SIB 51 06 26

NOISE COMING FROM TAILGATE TRIM PANELS

E-Series	Model Description
G26	4 Series Gran Coupe, including i4 Battery Electric Version (BEV)

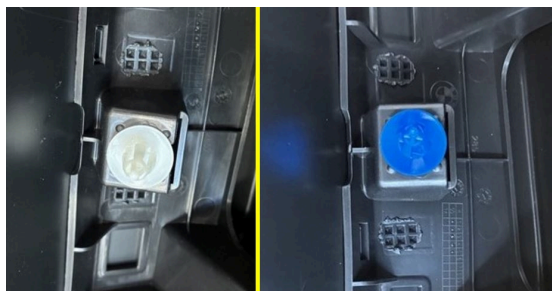
While driving on rough surfaces, a “tapping” noise can be heard from the tailgate area (arrows).

Over time, the clips on the tailgate trim panels develop excessive play.

Replace the white-colored clips with updated blue clips.

- **Replace all the existing white clips with the new updated blue clips**
- Reassess the vehicle and noise
